**HILLSIDE AT LORSON RANCH**

**EARLY OVERLOT GRADING / EROSION CONTROL PLANS**

Engineering Review  
03/30/2022 8:50:30 AM  
dsdrice  
JeffRice@elpasoco.com  
(719) 520-7877  
EPC Planning & Community  
Development Department

**COVER SHEET  
EARLY GRADING AND  
EROSION CONTROL PLAN**

**FOREBAY NO. 1 DETAIL**  
SCALE: 1"=5'

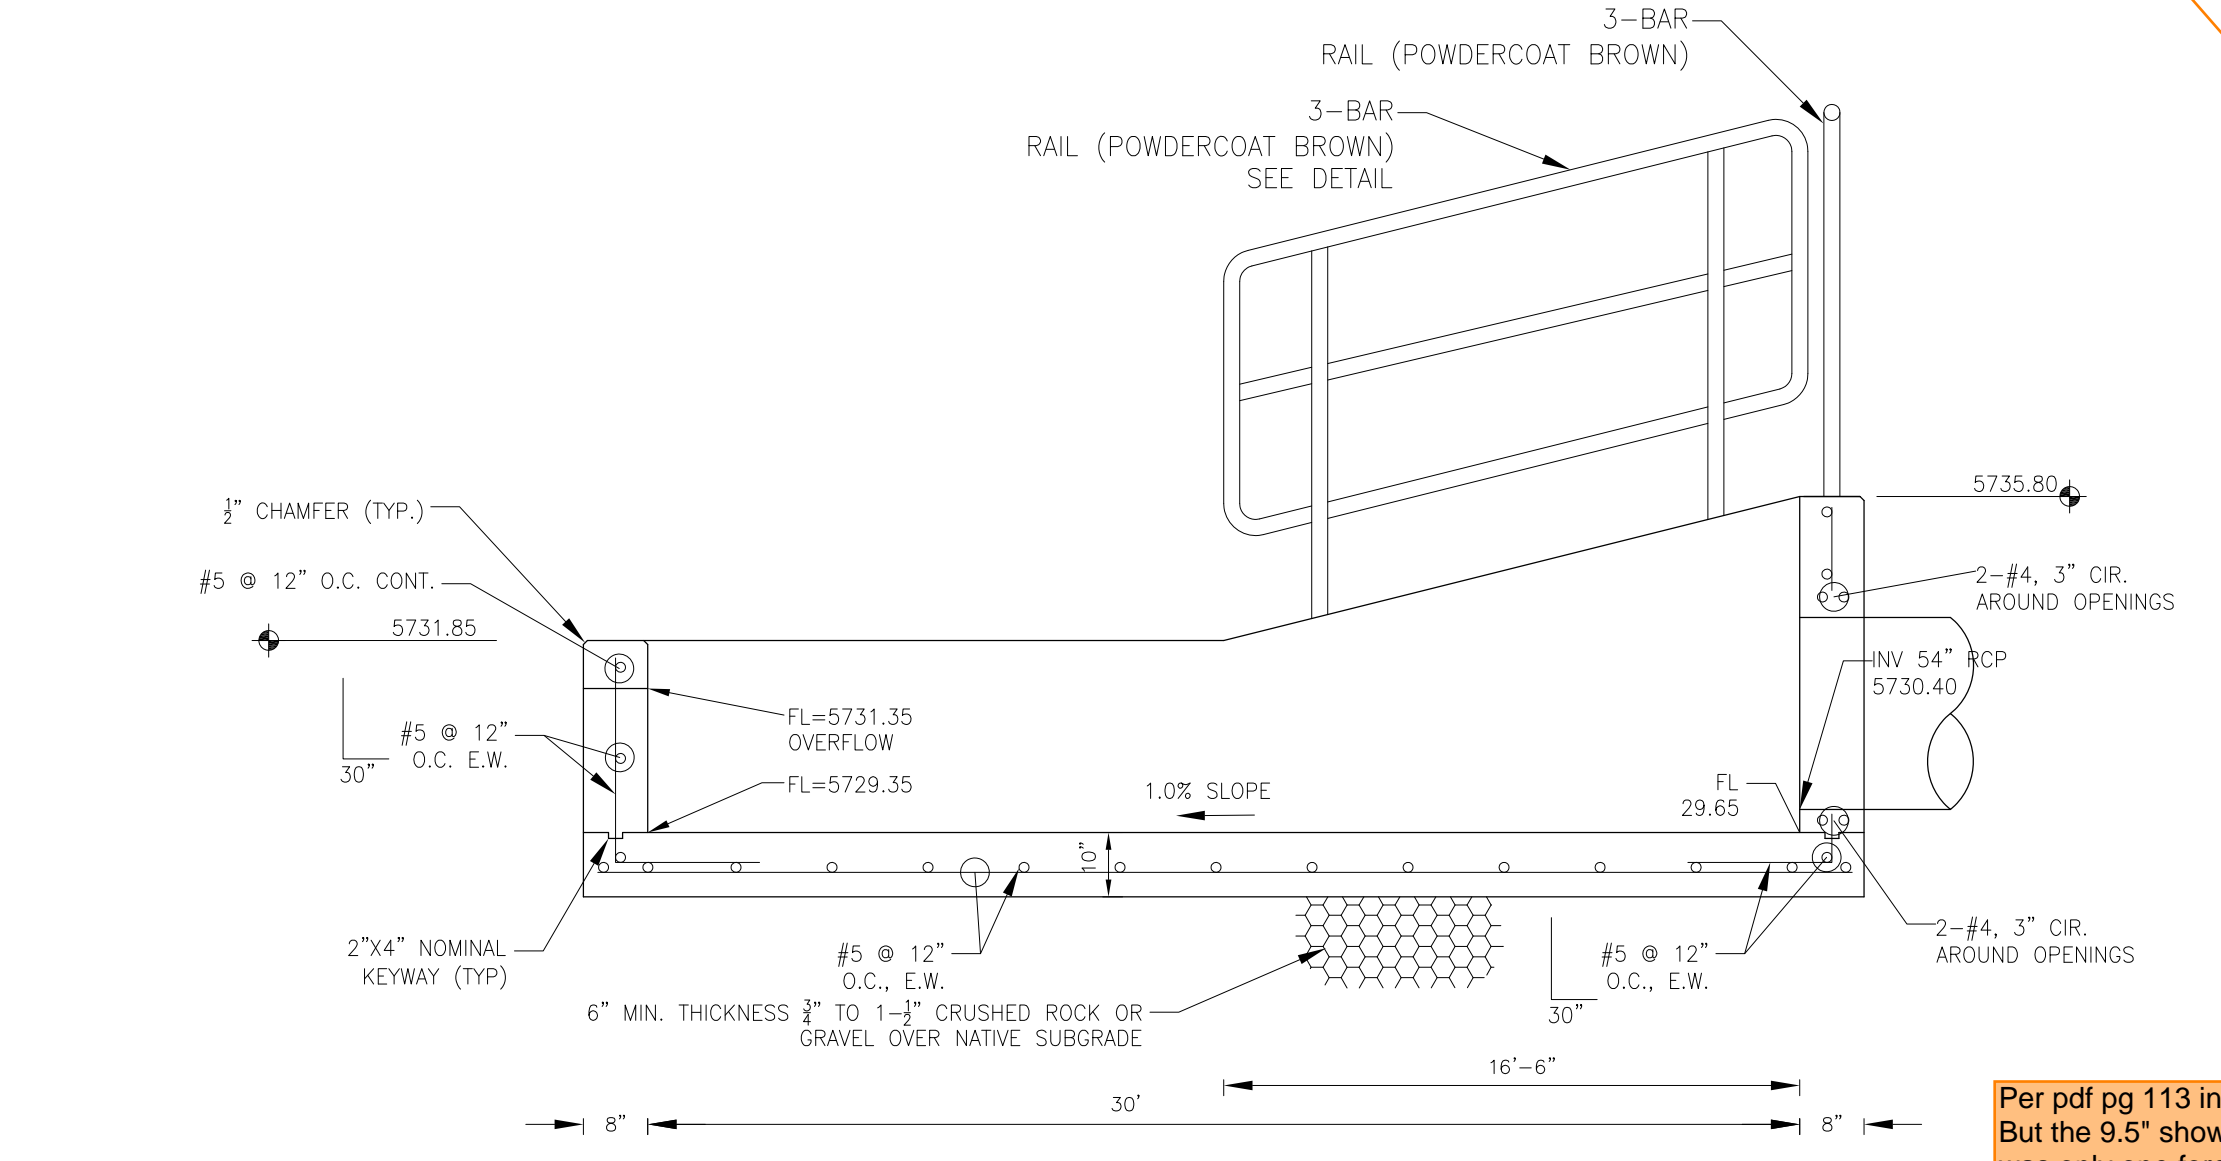
double check volume calcs for the combined two forebays that they meet the min volume req's shown on pdf pg 113 of PDR.

Per pdf pg 113 in PDR, this should be 9.5'. But the 9.5' shown on that page is for if there was only one forebay for the whole pond. So you will need to show separate calcs for each forebay to determine notch size and volume for each.

show calcs for this notch in the FDR for final plat.

WQ POND G  
1"=20'

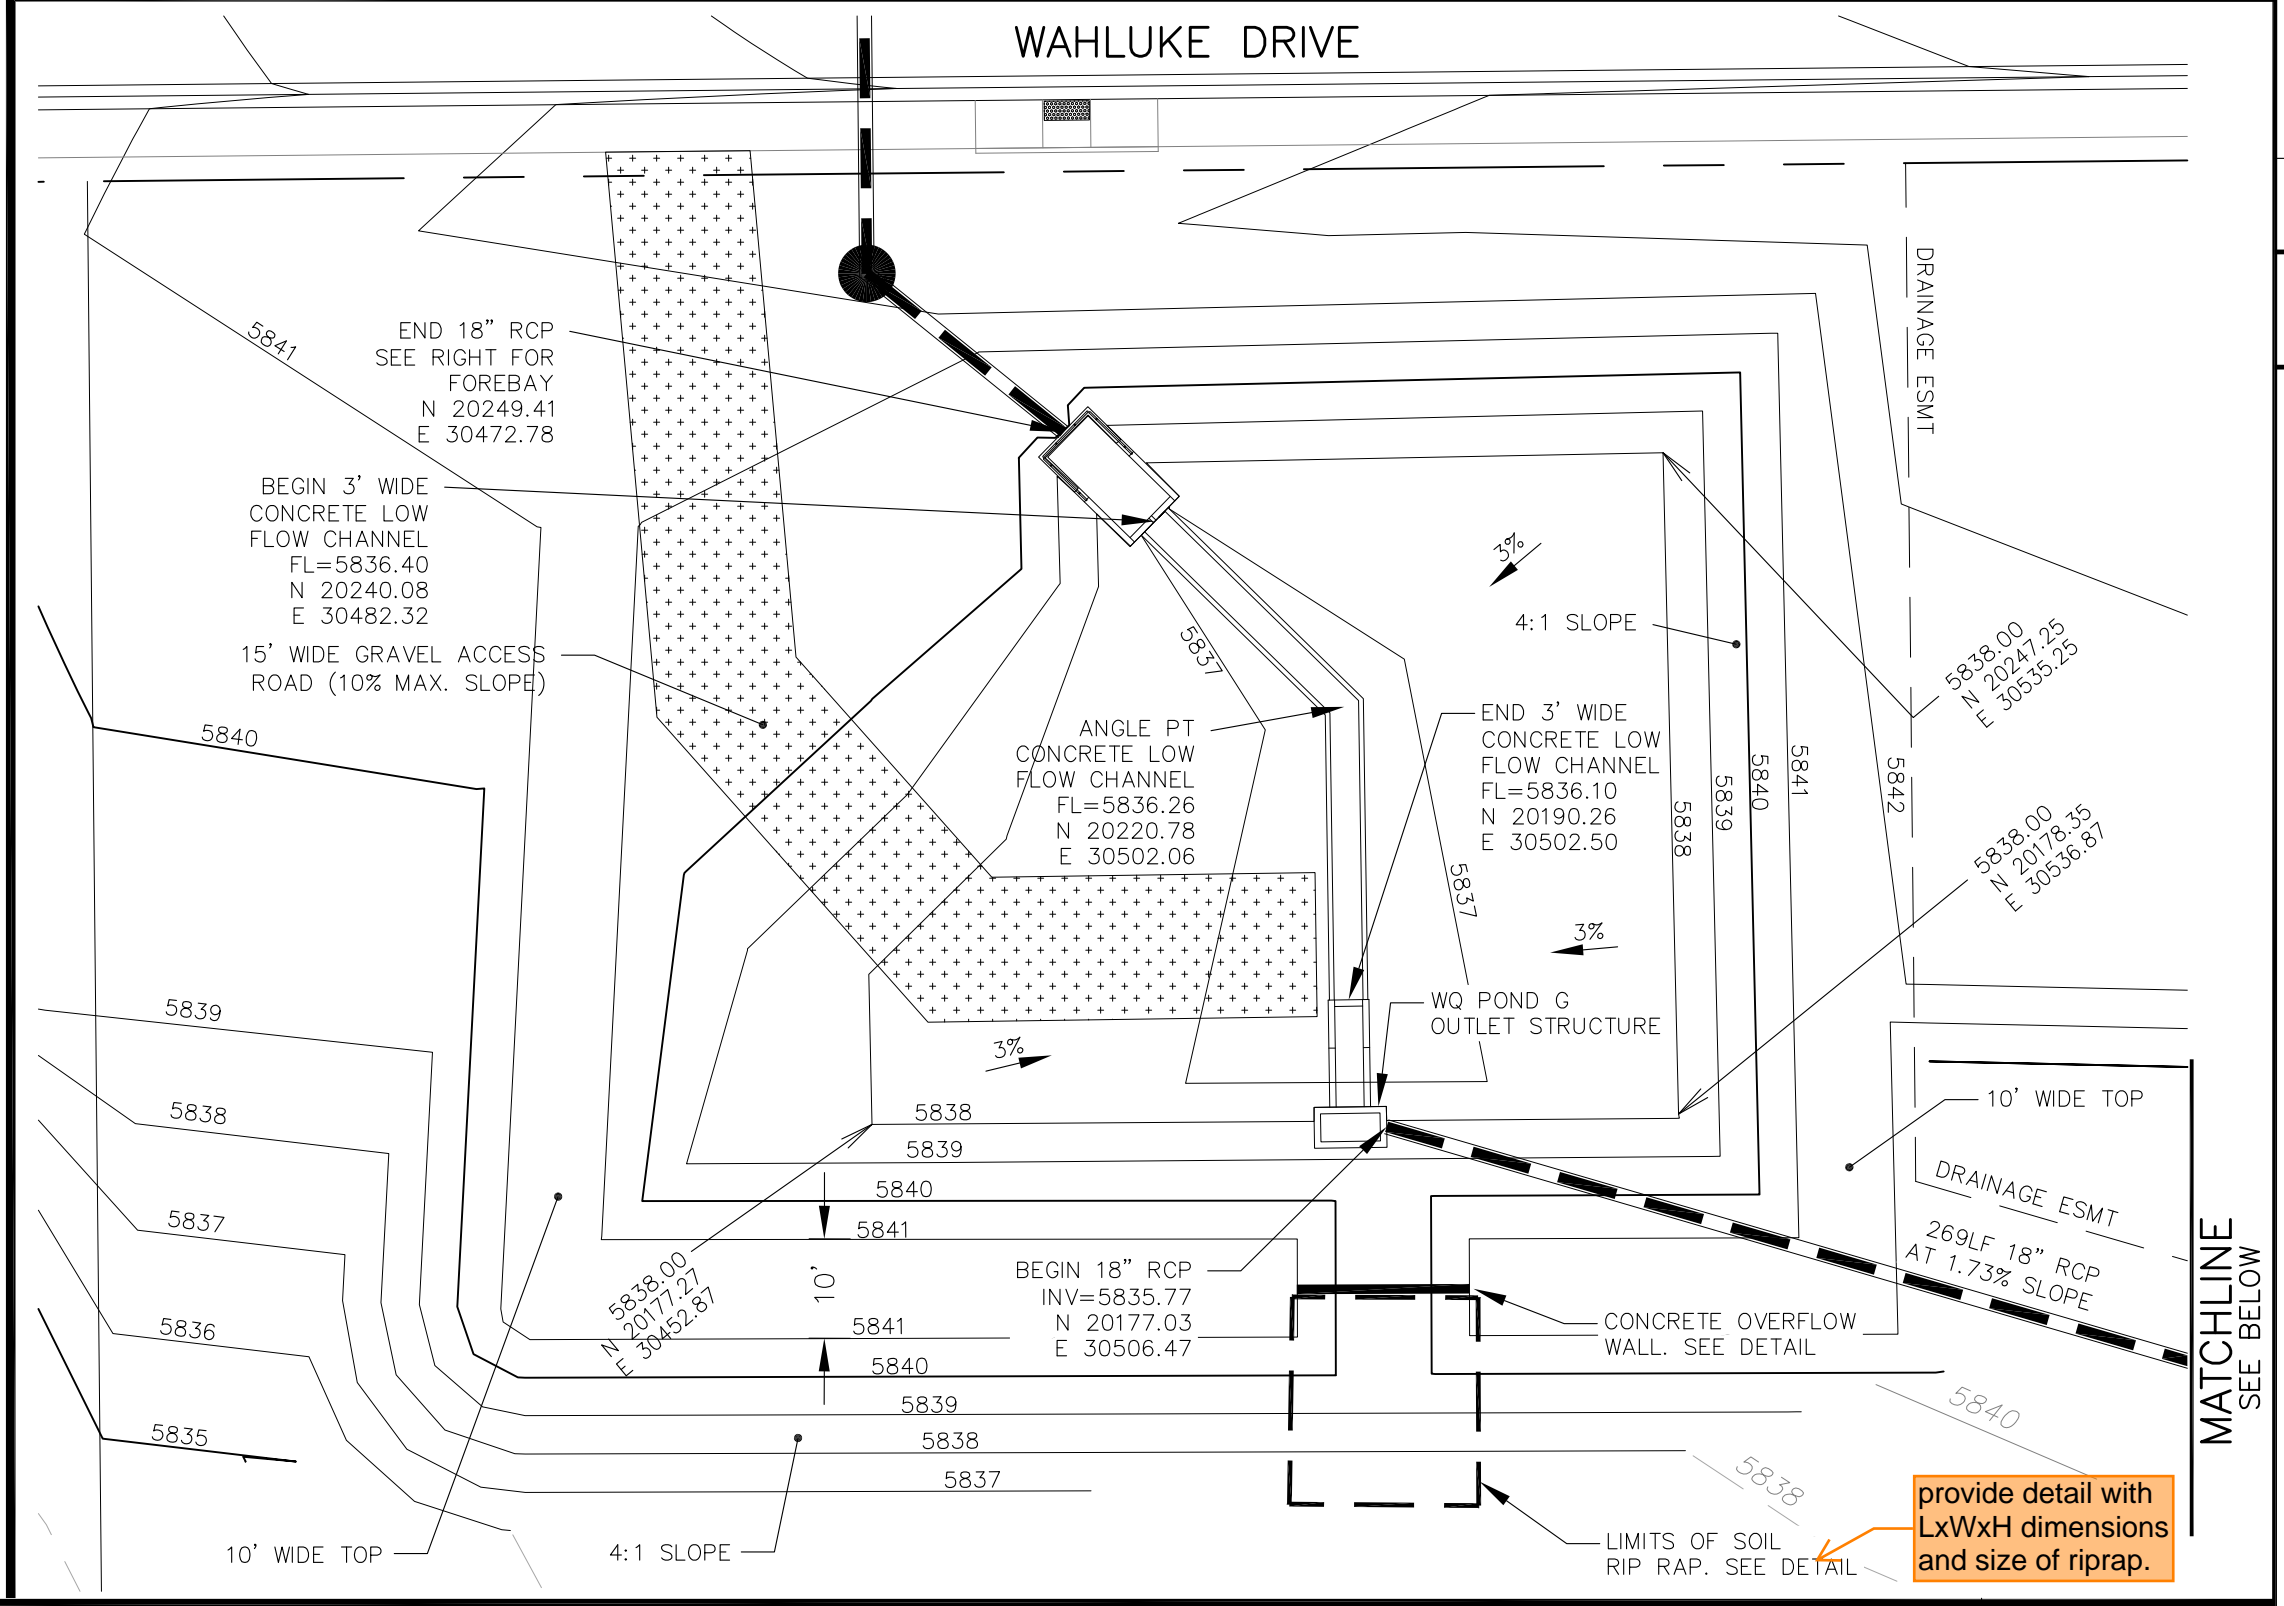
double check volume calcs. I get 0.0033 ac-ft, whereas pdf pg 125 of PDR states min should be 0.004 ac-ft.  
6ft x 12ft x 2ft / 43560 sqft/ac = 0.0033 ac-ft.

WQ POND G  
POND DETAILS  
AND TRICKLE CHANNEL

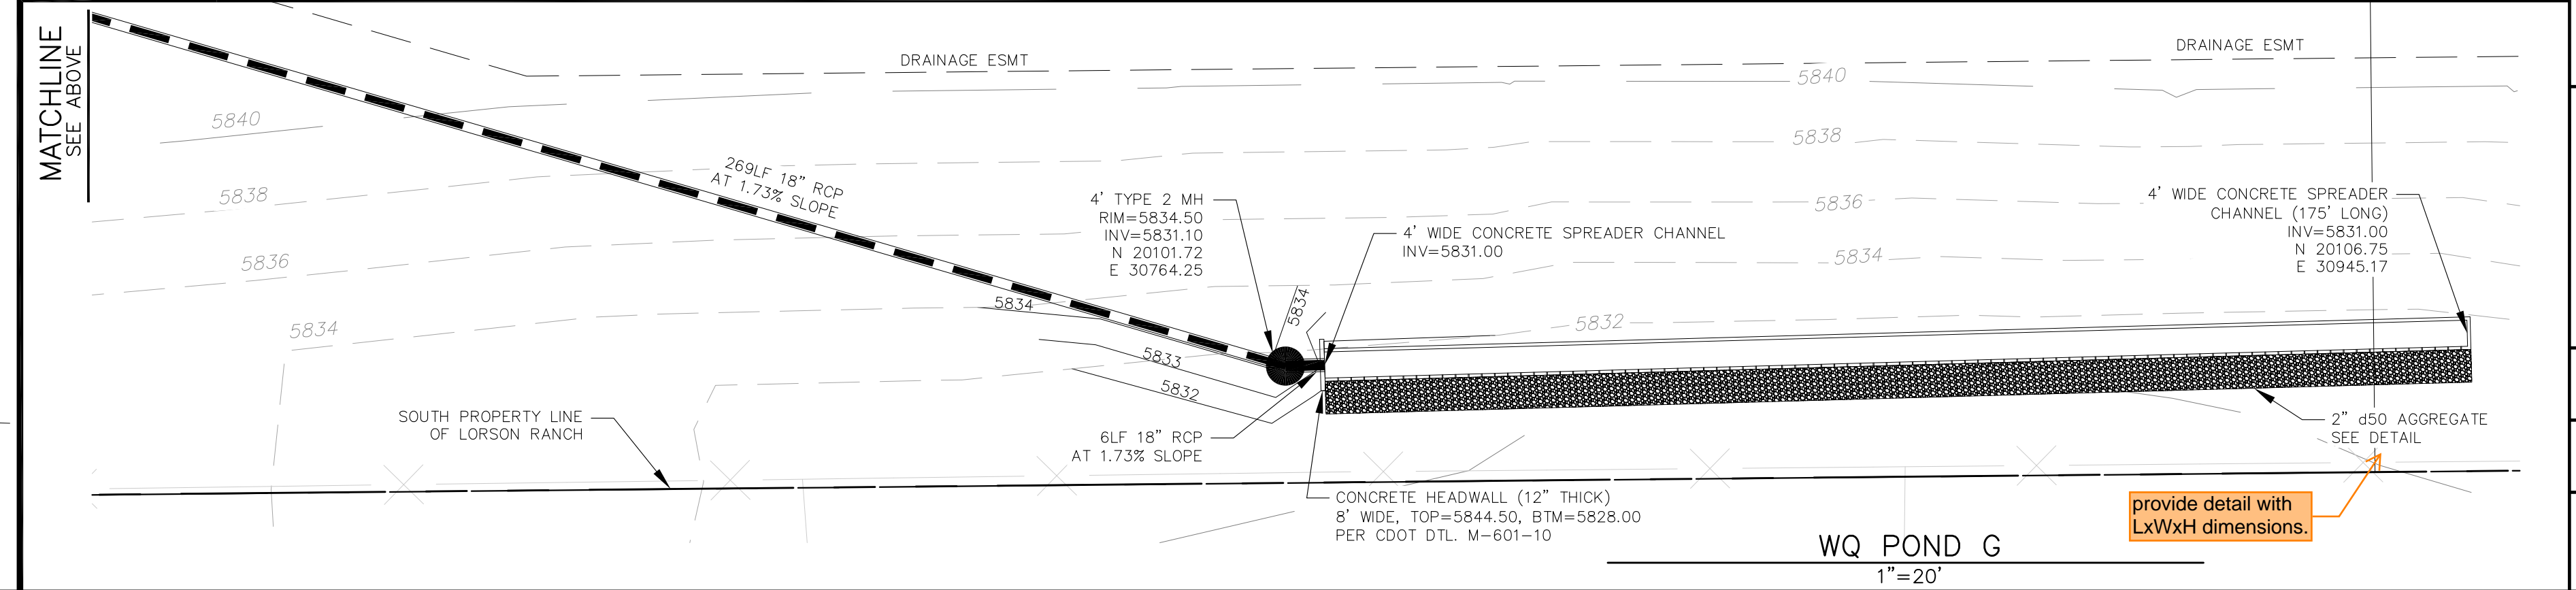
Remove "WQ." Per pdf pg 28 of the PDR, this is a full spectrum detention pond, not a WQ Pond.

GRATE 1 NO SCALE

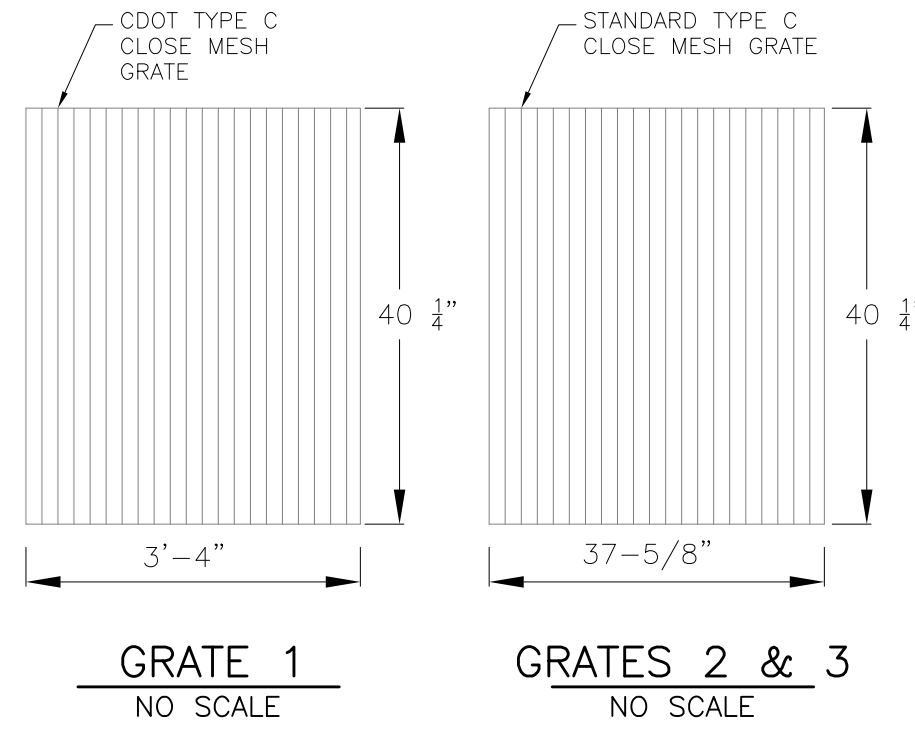
pdf pg 121 of PDR actually shows length and width switched (ie: box turned 90 degrees). Revise on here or in FDR.

**WQ POND H  
 POND GRADING AND  
 CONCRETE SPREADER CHANNEL**

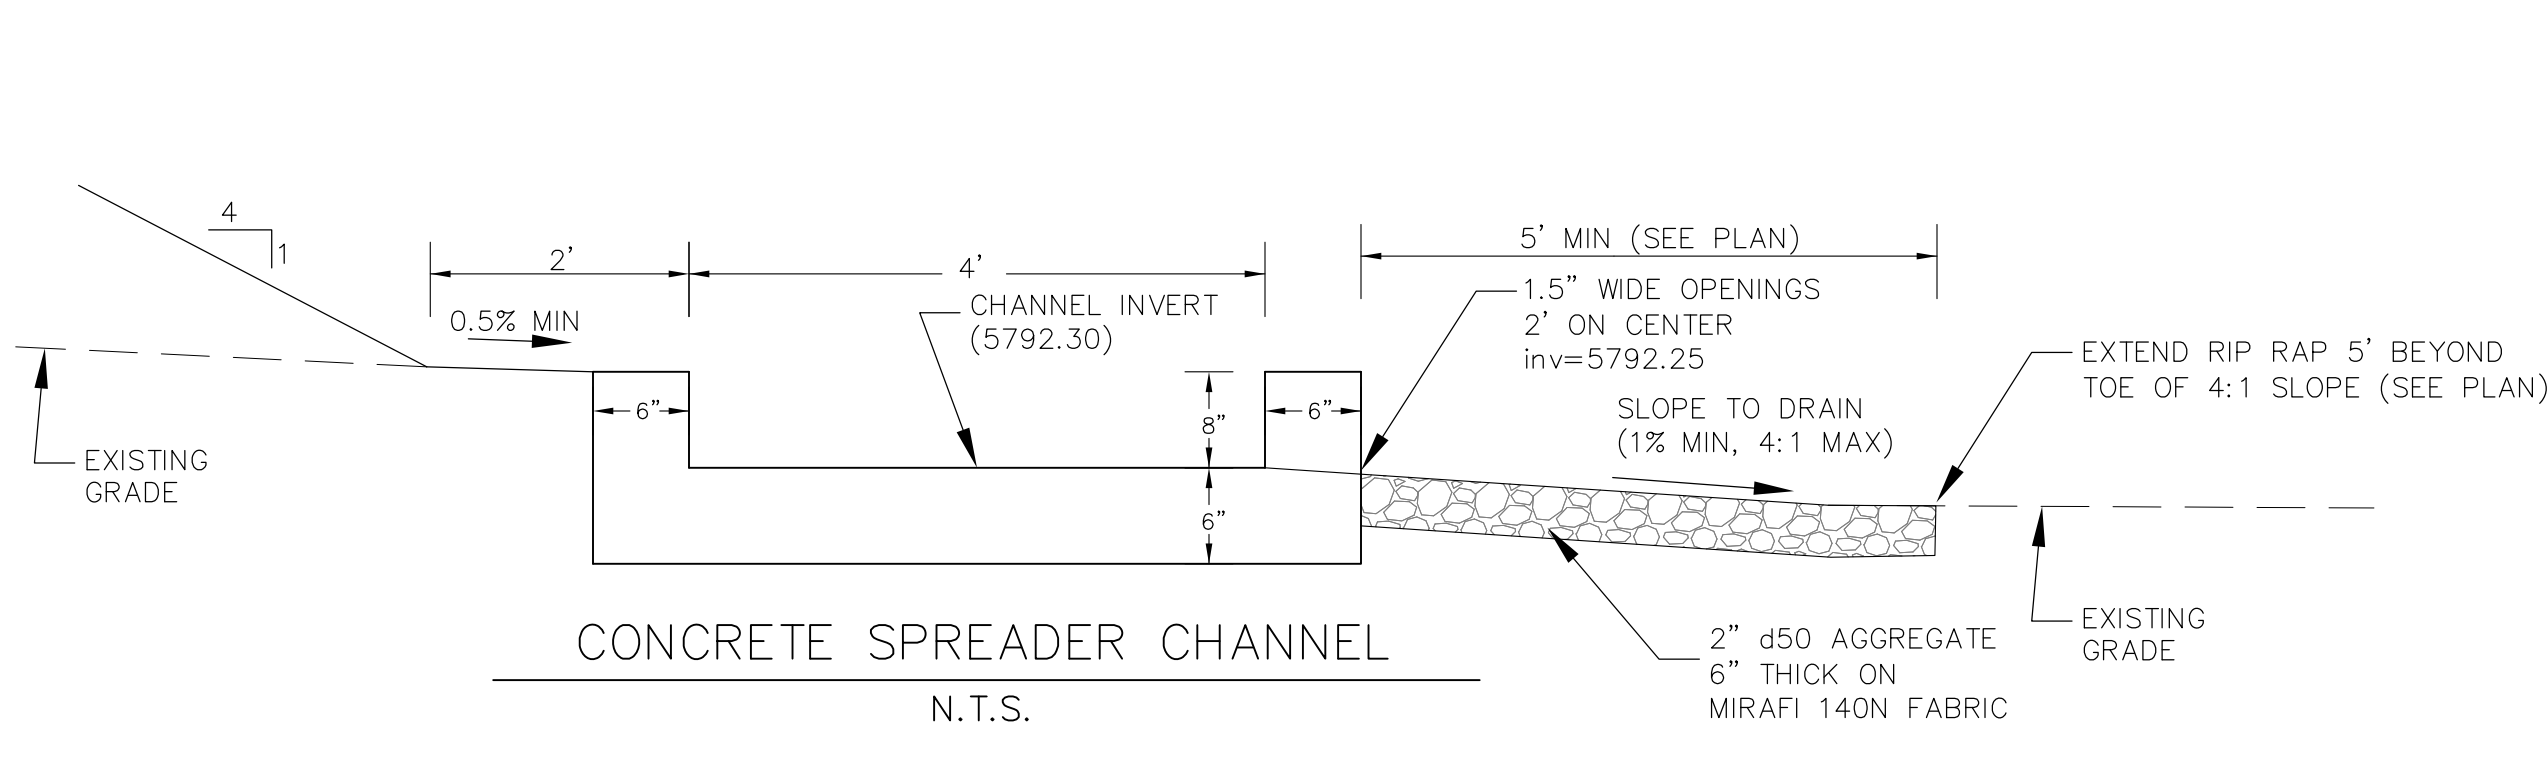
Remove "WQ." Per pdf pg 28 of the PDR, this is a full spectrum detention pond, not a WQ Pond.
